DEPARTMENT OF ENERGY

Federal Energy Regulatory Commission

[Docket No. RM95-9-003]

Open Access Same-Time Information System and Standards of Conduct

Guide 4.4: The following state transitions in Figure 4-1 are recommended practice in OASIS Phase 1-A.

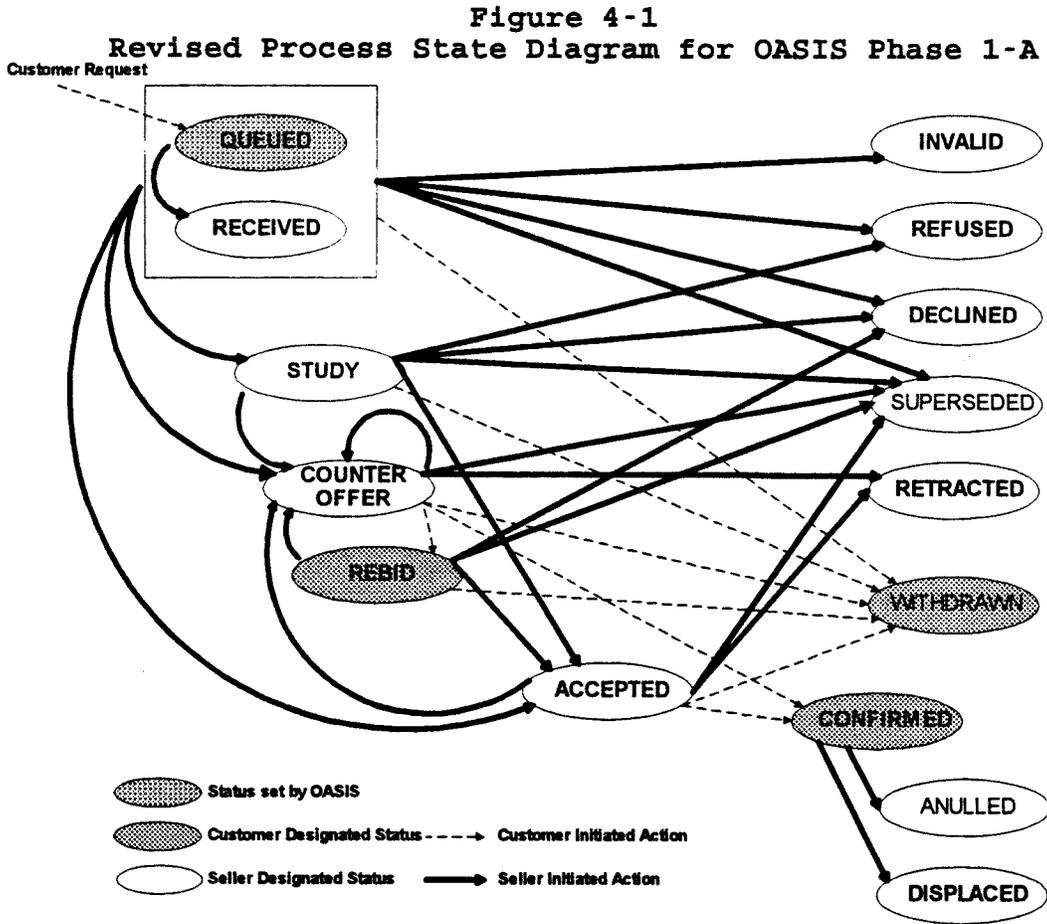
ECI argues that the June 19 Report proposal would revise the process state diagram appearing in the S&CP Document by adding SUPERSEDED to indicate that a request is preempted prior to confirmation by the customer. ECI further argues that this change results in a contradiction between June 19 Report's process state diagram in Guide 4.4 (Figure 4-1), and an order issued by the Commission on July 17, 1998.⁶⁴ ECI argues that the July 17 Order holds that "there is no right to supersede while engaged in negotiations (*i.e.*, pending), until there is a refusal to match."⁶⁵

ECI also argues that the process state diagram's treatment of counteroffers needs revision. In discussing this change, the June 19 Report states:

ECI has raised a number of objections to Part 4B of the June 19 Report (*i.e.*, "Phase IA Negotiation Process State Transition Diagram"). One of ECI's objections is that the proposal in the June 19 Report would revise the process state diagram in the S&CP Document.

Second, ECI contends that the addition of "SUPERSEDED" to the report's process state transition diagram (at Figure 4-1) is inconsistent with the Commission's denial of ECI's complaint against PJM in the July 17 Order,⁷³ because ECI maintains that the July 17 Order held that "there is no right to supersede [a pending request for service] while engaged in negotiations (*i.e.*, pending) until there is a refusal to match."⁷⁴

While this was true at the time when ECI filed its comments, it is true no longer. Subsequent to the filing of ECI's comments, the Commission approved a revised S&CP Document that contains the same process state diagram recommended by the June 19 Report.⁷²

Upon review, the definition of "SUPERSEDED" in the Data Element Dictionary and in section 4.2.10.2 of the S&CP Document could be improved. We propose to revise the definition by substituting the word "preempted" in place of "displaced." We invite the comments to this NOPR to address this issue.
